**YESLER TERRACE
BLOCK 5 | BLDG B**

EAST DESIGN REVIEW BOARD

DESIGN RECOMMENDATION MEETING

1020 S MAIN ST | PROJECT #3028954

LEVEL 1 COURTYARD PLAN

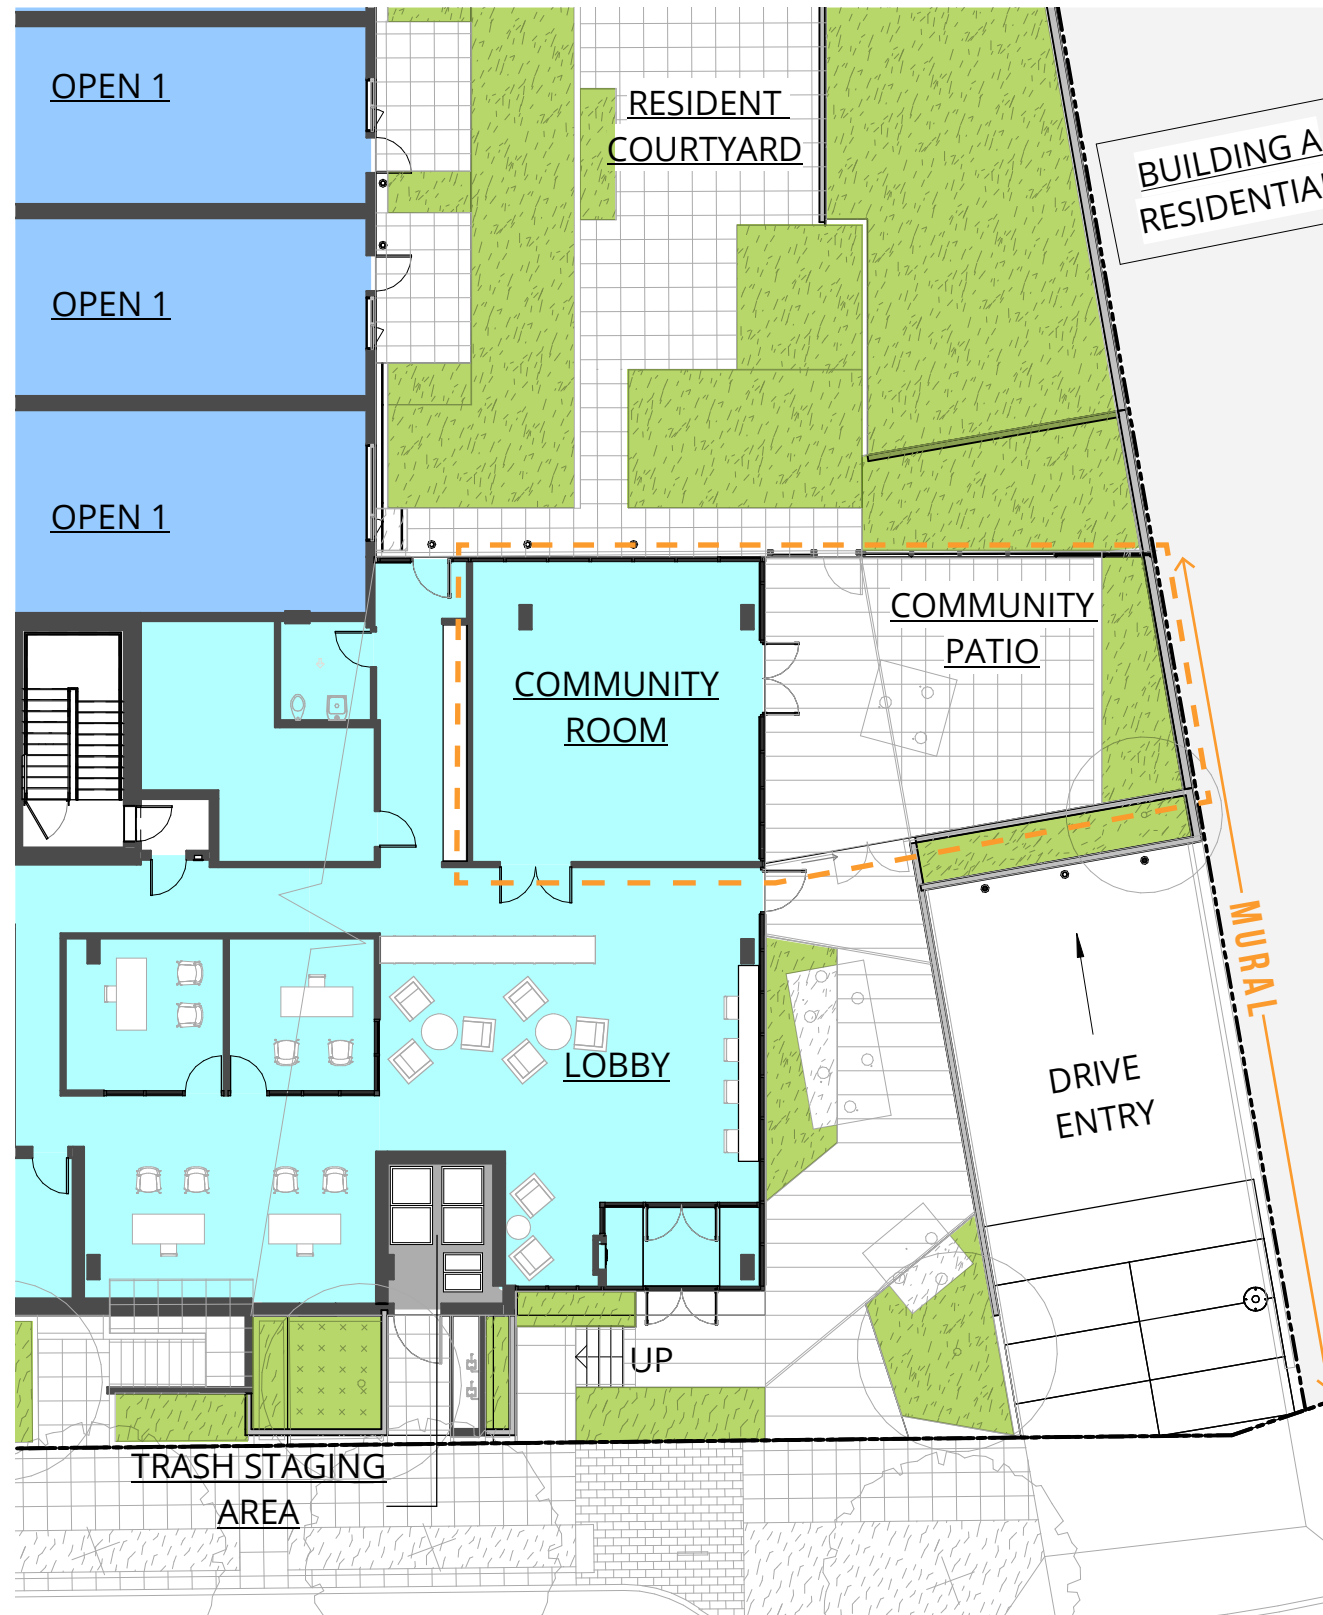
d. The Board strongly approved of the direct connection between the courtyard and the street which provides large scale modulation along S Main St and diminishes the appearance of one long building when considered with Phase 1 (Building A). The Board also supported the thoughtful development of the courtyard including the overall proportion, function and arrangement of surrounding uses.

e. Related to massing, the Board indicated early support for the requested departure for a reduced setback area along the access drive, as the encroachment establishes a singular vertical break which better differentiates the two phases and breaks up the bulk and scale of the frontage.

The courtyard configuration and modulation along S Main St has been maintained since EDG. The main lobby entry remains at grade with the sidewalk. The setback departure supported by The Board allows for the courtyard to open up the building massing.

The Board approved of the dark material at the lobby massing, this has been maintained. Although Building B is not at a gateway location, in response to Recommendation meeting comments for Bldg A the blue accent color has been incorporated at the primary entry as a signifier of 'Entrance.'

Option 1 incorporates the blue accent color at the entry canopy and in-grade LED light strips. The incorporation of blue is kept simple to allow for the mural and community courtyard artwork to be the more prominent language in the space. Option 2 adds the blue accent color in a pattern on the black facade. Option 3 maintains the original design with no accent color.

1 TYPICAL POCKET PARK PATIO SECTION

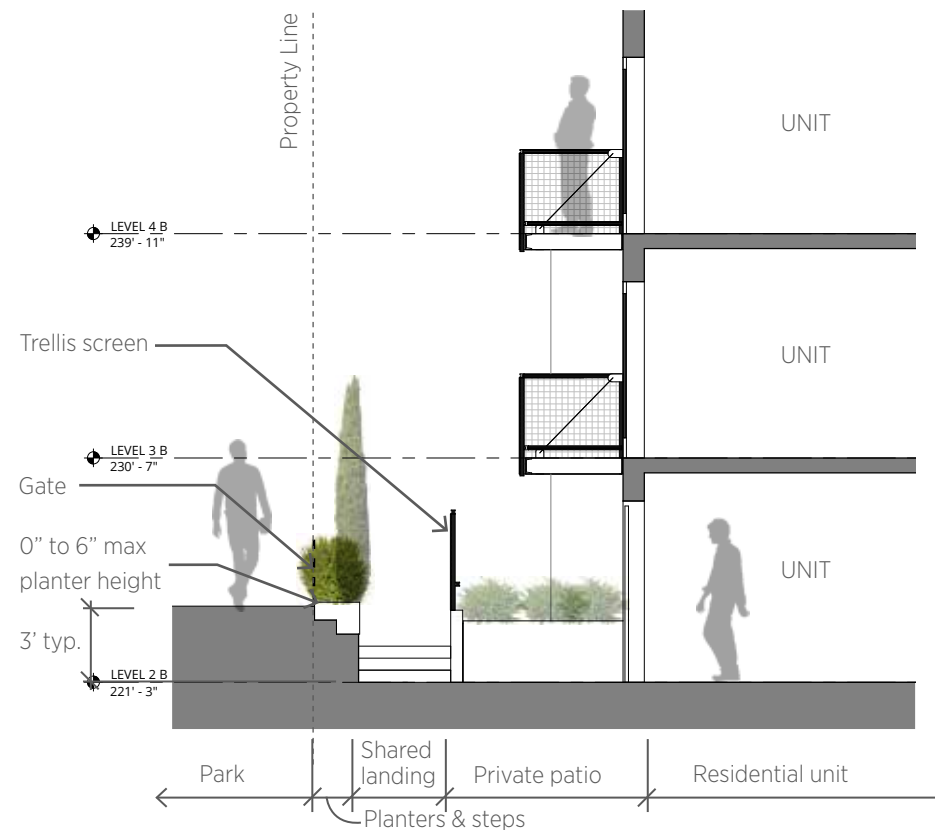
b. The Board supported the revised residential frontage facing the pocket park as the refined entry sequence creates a front door experience for the individual units and thoughtfully transitions to the pocket park. The Board initially supported the related departure request as the slightly below grade frontage is mitigated with the proposed series of stepped panthers and stoops.

The residential frontage facing the pocket park with 8 park facing entries have been maintained and further dispersed since EDG. Each patio entrance is separated from the park through several layers of privacy.

STOOP WALK

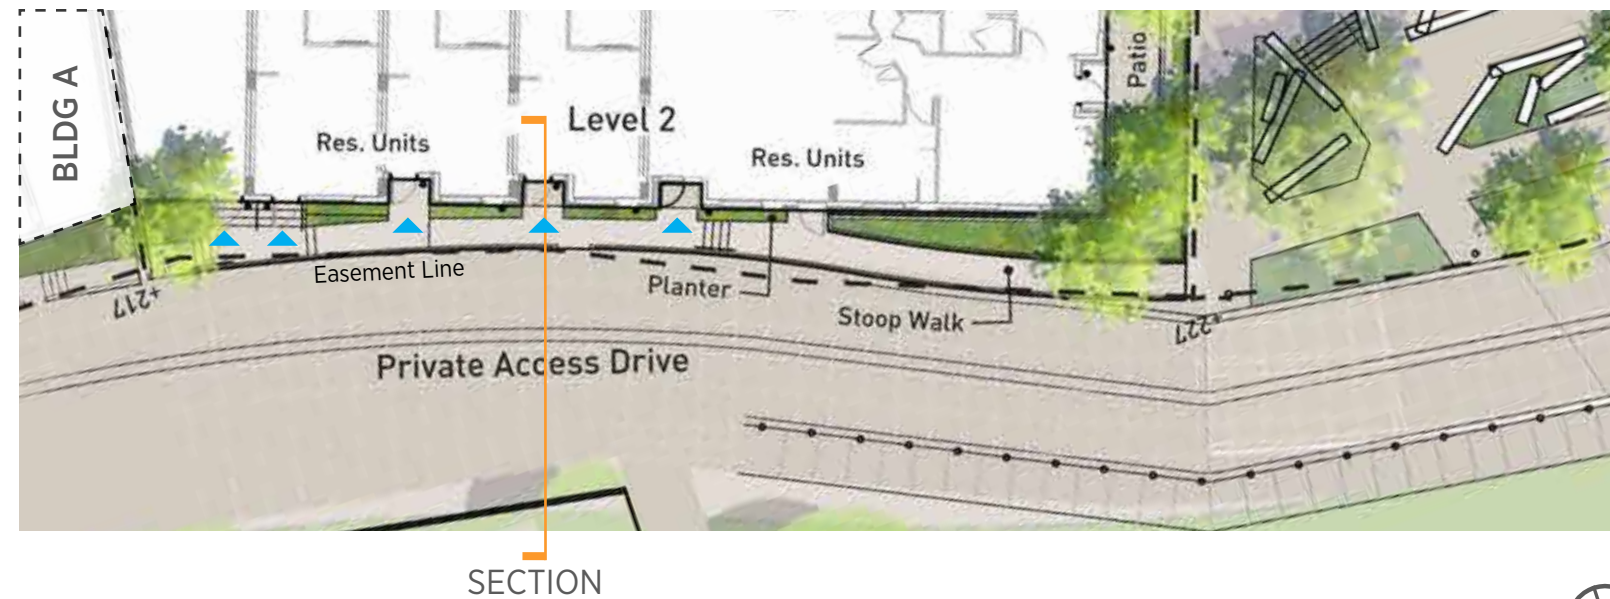
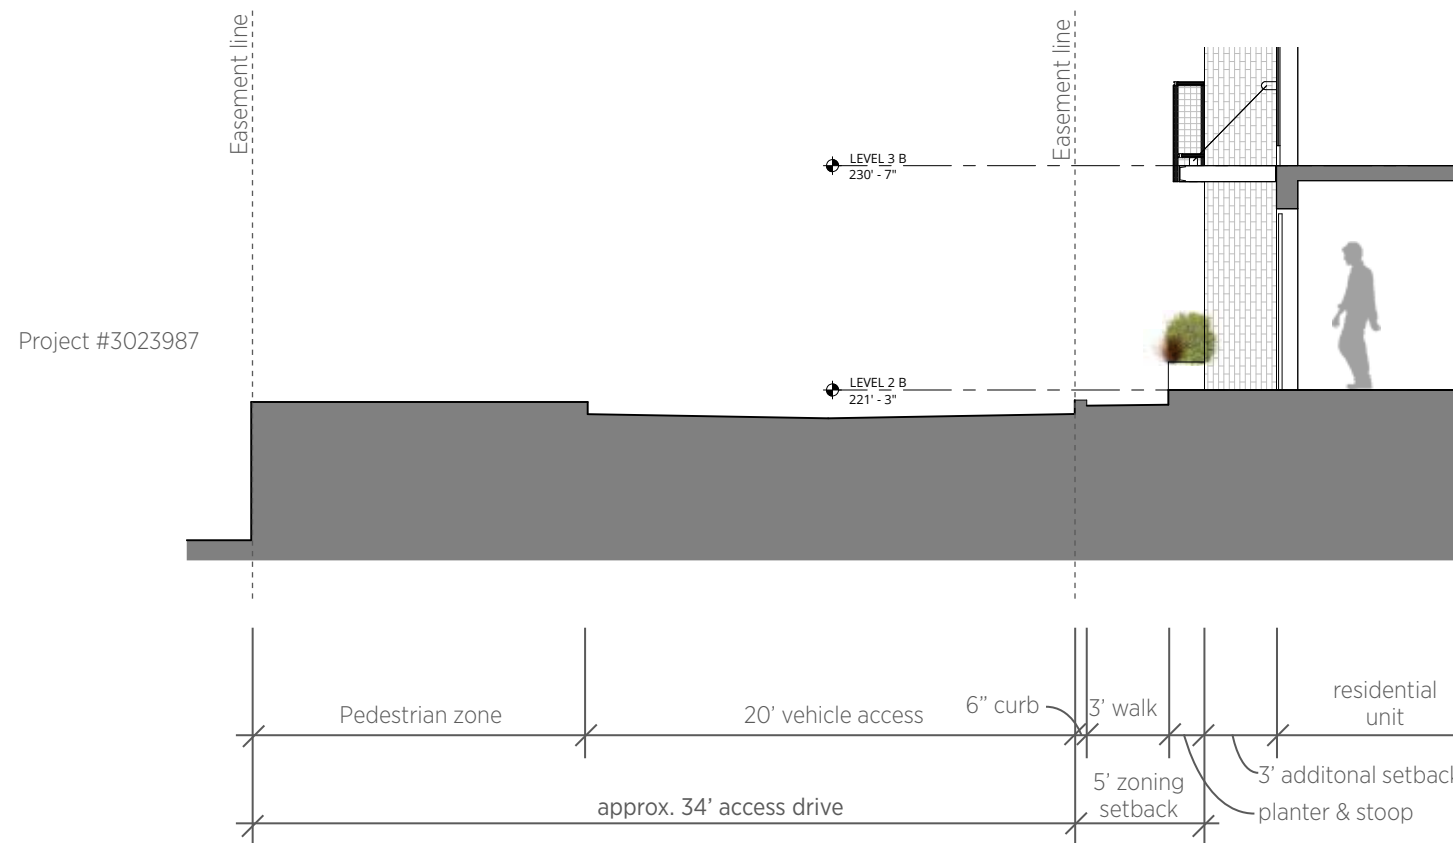
c. For the access drive frontage, the Board strongly supported the proposed alternate with direct entries and shared circulation space, referred to as the “stoop walk.” The Board agreed the design appropriately incorporates CPTED principles, which recommended “eyes on the street” and maximizing the number of ground-related residential entries, addresses safety concerns and better meets the intent of the access drive to function as a woonerf.

As discussed in EDG 2, the “stoop walk” has been maintained along the Access Drive at Building B. The residential entries along the stoop walk have been maximized with an additional 2 entries added, totalling at 5 entries spread across the Building B Access Drive frontage. This brings the total number of entries in both buildings along the Access Drive to 12. There will be several points of pedestrian access onto the stoop walk based on the topography.

The stepping walkway mitigates the slope and is accessible by the public. Artwork will continue to be incorporated at the planters along the access drive, per the Building A final Recommendation meeting.

3. WATER MANAGEMENT

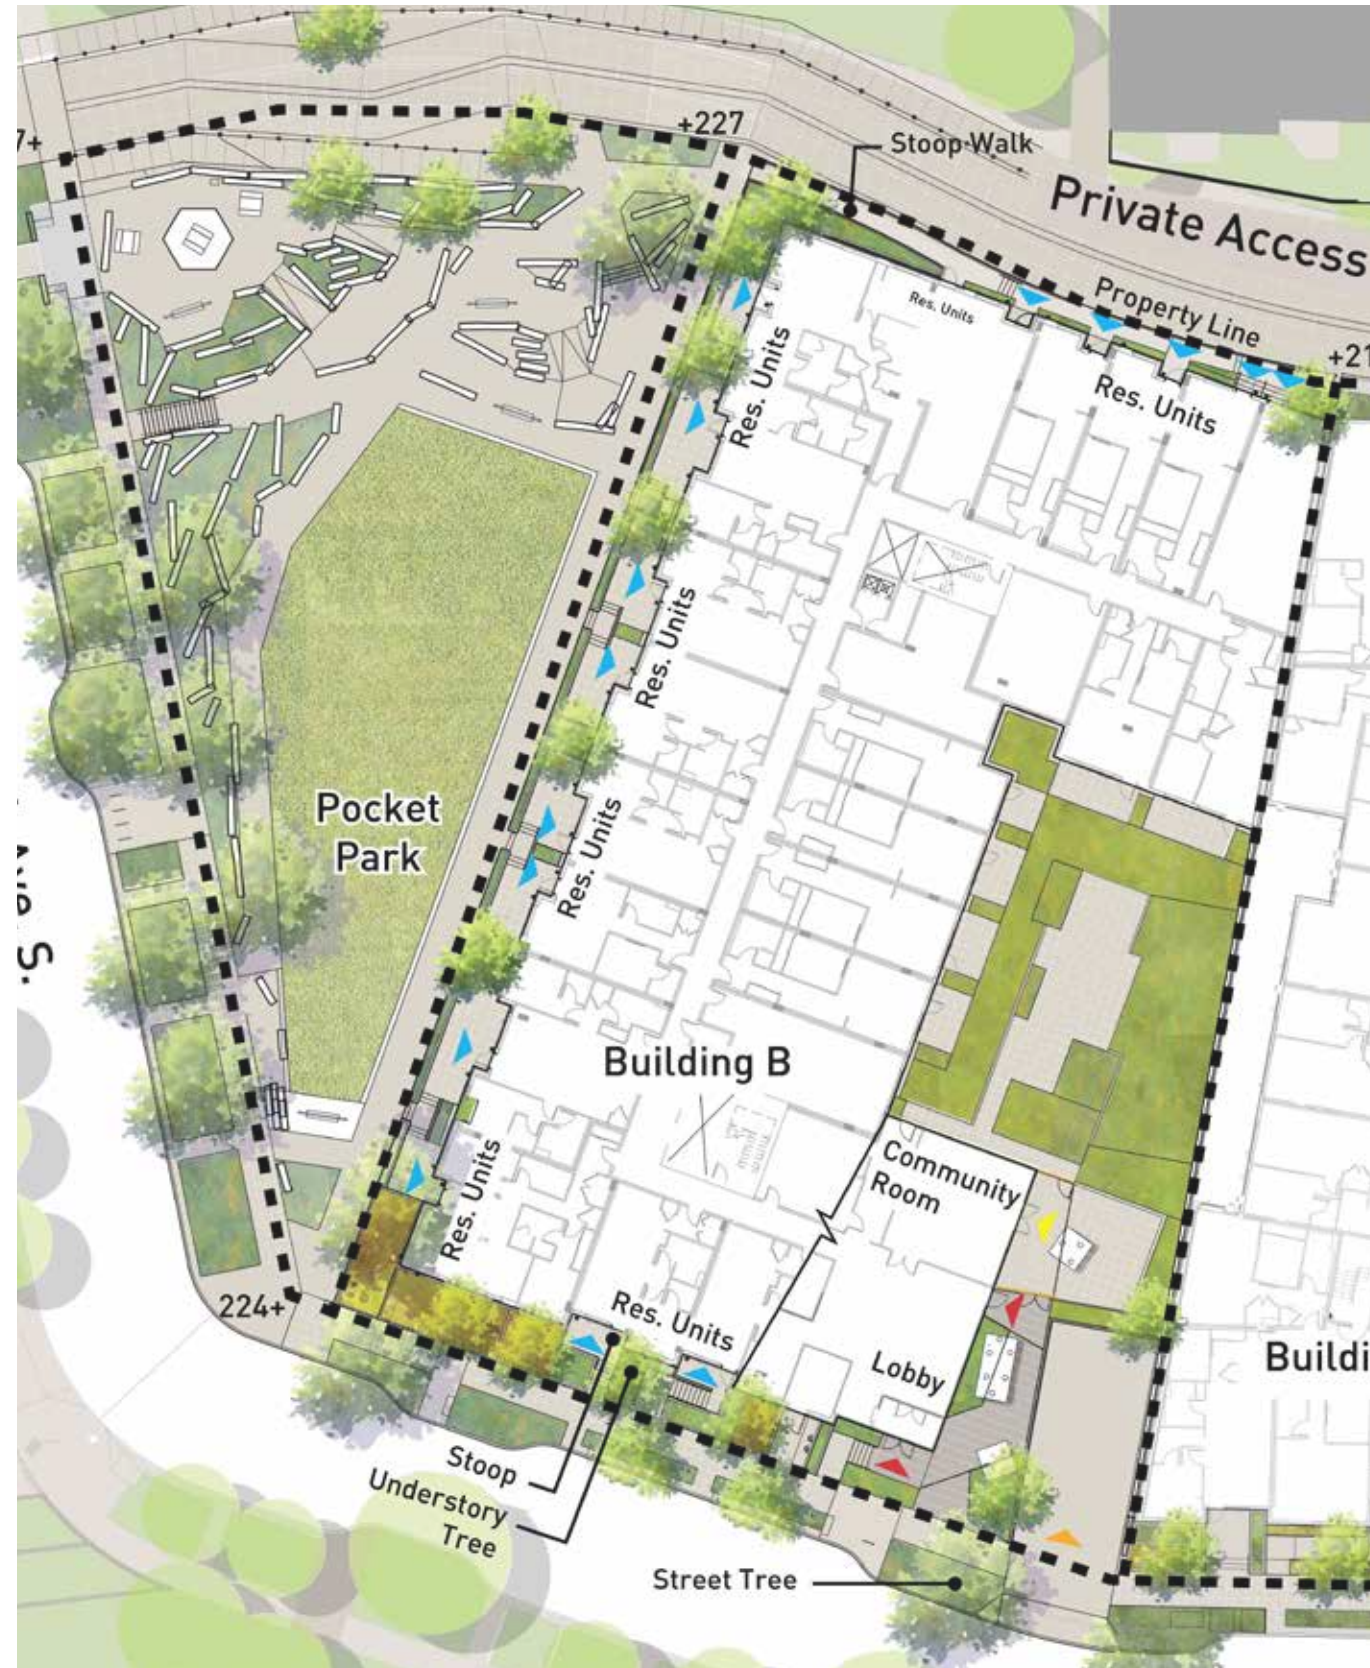
The Board supported the proposed bio-retention and stormwater planters near the S Main St sidewalk as the design takes advantage of the site topography and has the potential to create visual interest for the pedestrian.

This concept both addresses stormwater management in environmentally responsible ways and creates expressive landscape that celebrates stormwater. Bioretention planters along S Main Street are repositioned and realigned to foster a greater public interest and enjoyment in a cascading form. Planters are allowed to step with site grade and continue under Lobby stair to allow moments of curiosity and varied perspectives.

Runnel/weir elements transport stormwater away from the building into bioretention planters. Runnels' layout compliments building edges and plant realignment.

● - - - ● BIKE PARKING ROUTE

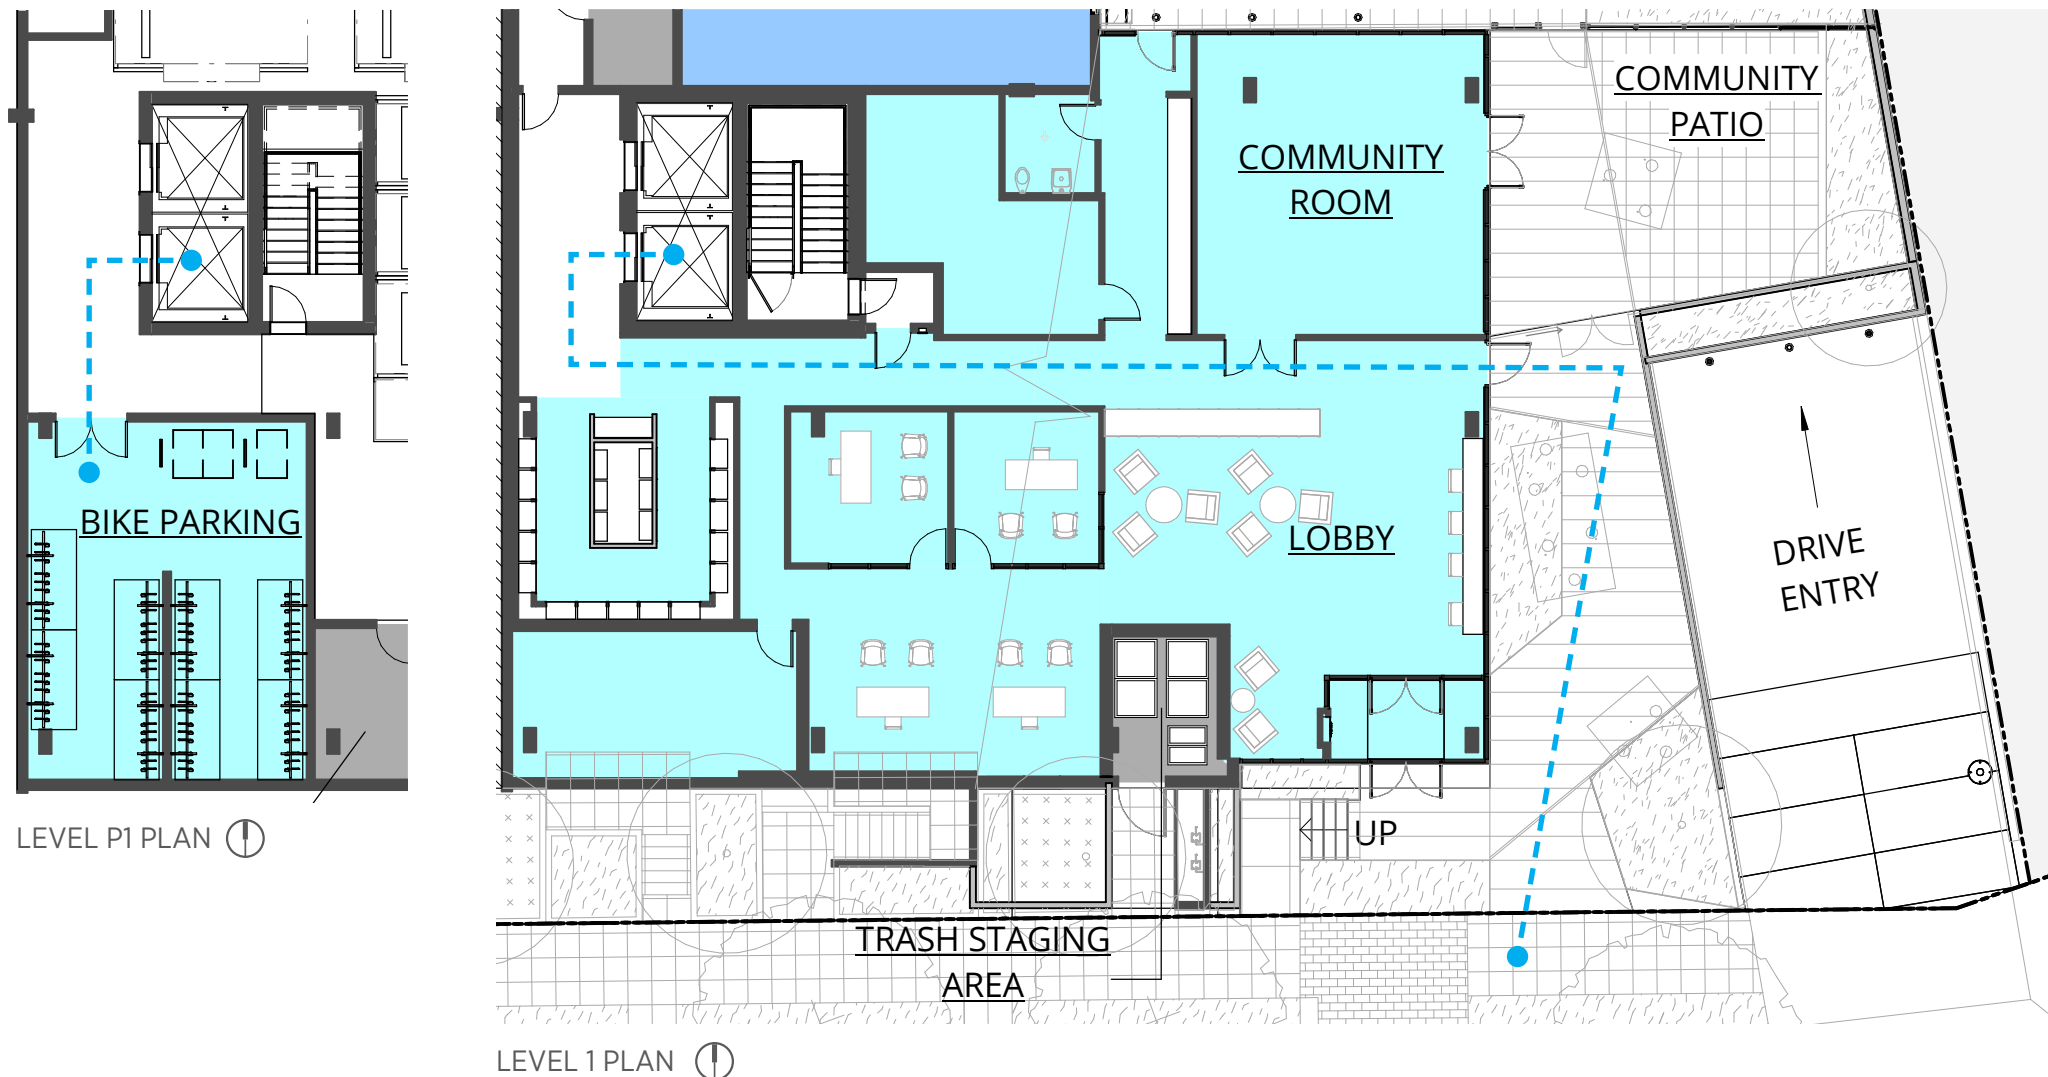
PL4-B-2 Bike Facilities

We are providing bicycle parking beyond what is required per code. The storage room is located on level P1 as shown on the diagram in this page. The most convenient access to this level can only occur along S. Main Street., through the lobby and down the elevator.

We have considered a direct and separate access to the elevator from the street, however due to the steep slope along S. Main Street as you move west, this direct access is impossible to achieve without making a cyclist's transport a bike down a set of stairs before one can reach the grade of the lobby level.
